PROJECT: 101 Nuwarra Rd, Moorebank.

BCA COMPLIANCE REPORT FOR DEVELOPMENT APPROVAL SUBMISSION

DATE: 29 November 2016
REPORT NO: 0193 – REV C - FINAL
PREPARED FOR: **Oar 2 Trust**

Figure 2 - the point to which egress is discharged from the building is less than the required 2/3 open

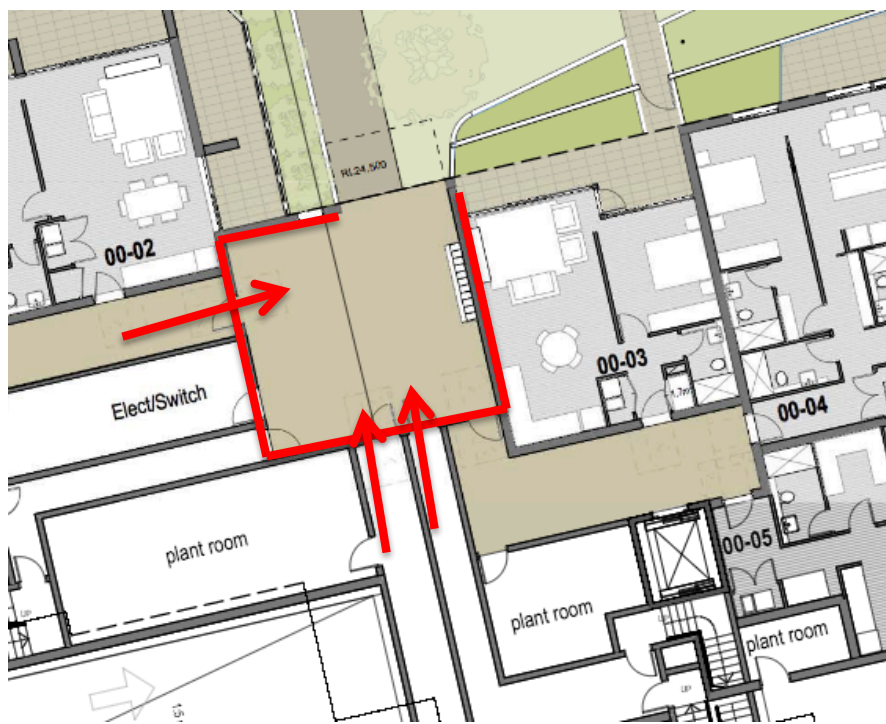
2. D1.7 Travel via fire-isolated exits

(b) Each fire-isolated stairway or fire-isolated ramp must provide independent egress from each storey served and discharge directly, or by way of its own fire-isolated passageway—

- (i) to a road or open space; or
- (ii) to a point—

(A) in a storey or space, within the confines of the building, that is used only for pedestrian movement, car parking or the like and is open for at least 2/3 of its perimeter; and

(B) from which an unimpeded path of travel, not further than 20 m, is available to a road or open space
